# County of Fairfax, Virginia

October 16, 2009

Re: Interpretation for RZ/FDP 2004-SU-009, Poplar Parc, Tax Map Parcel 44-4 ((1)) 9A: Elevations

**CHAPEL HILL**

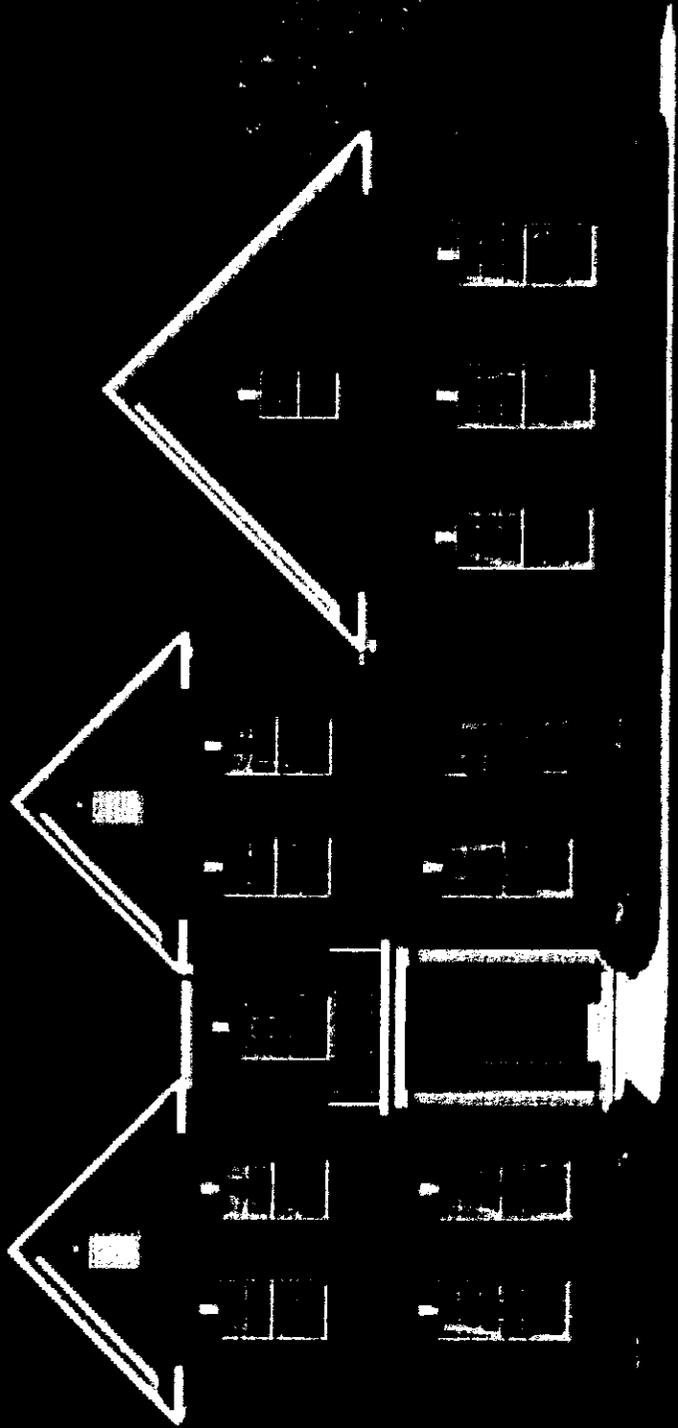
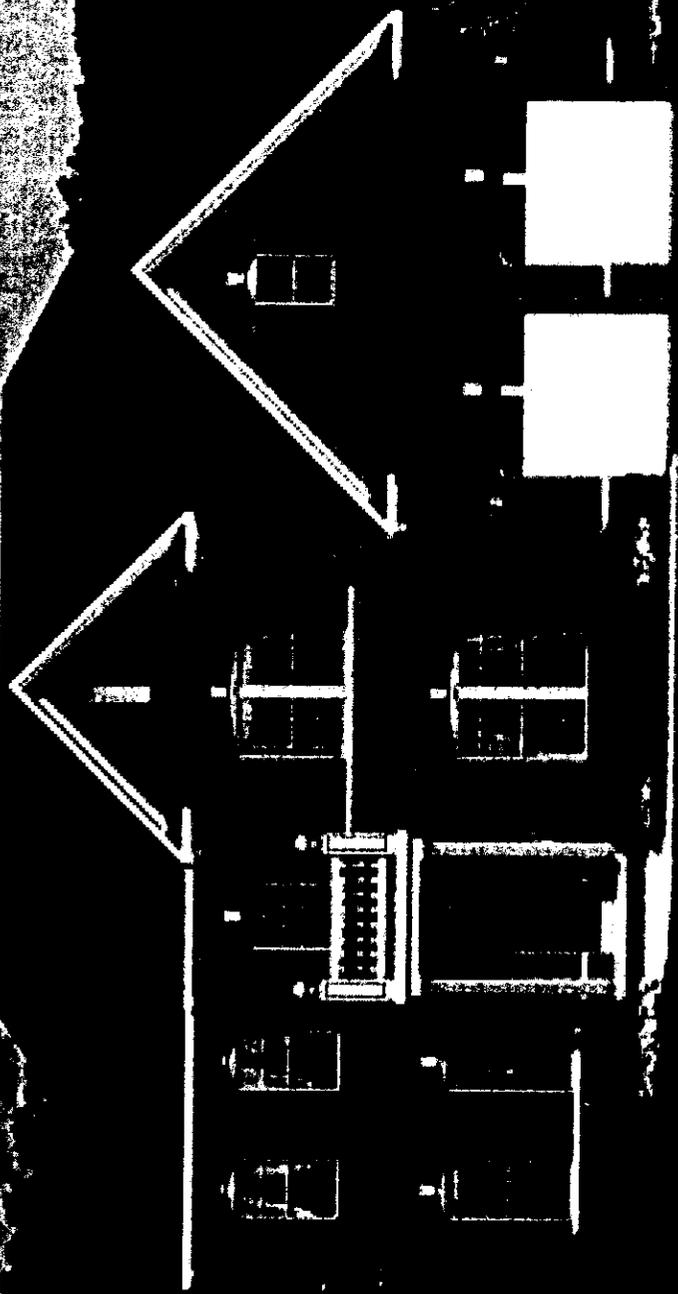
Based on Staff's comments with regard to the previously submitted elevations, NVR has revised their elevations and produced new rendered graphics in color. Enclosed please find elevations for six different house types—Chapel Hill, Clifton Park, Monticello, Regents Park, Remington Place and Wynterhall. There are a minimum of three distinct variations for each of the homes, several with side-loaded garages. Please accept the enclosed elevations in lieu of the previously submitted elevations that were identified as Exhibit E.

As can be seen, the garage entrances have been redesigned so that there are separate, individual garage doors; all double garage doors have been eliminated. The new garage door designs include details such as raised panels and decorative glass inserts. These improvements enhance the homes' handsome facades and are in conformance with the architectural elevations depicted with the rezoning approval.

I have reviewed your proposed elevations and have determined that the proposed elevations are in substantial conformance with the proffers and development plan, and are compatible with the general style and materials of the existing homes, subject to conformance with the Proffer 7 requirement for special architectural treatment for the sides of units that are visible from the public right-of-ways. I understand that you have acknowledged the existence of a HOA covenant that requires a minimum house size of 4,000 square feet and have stated that all of the proposed dwellings will conform to that standard.
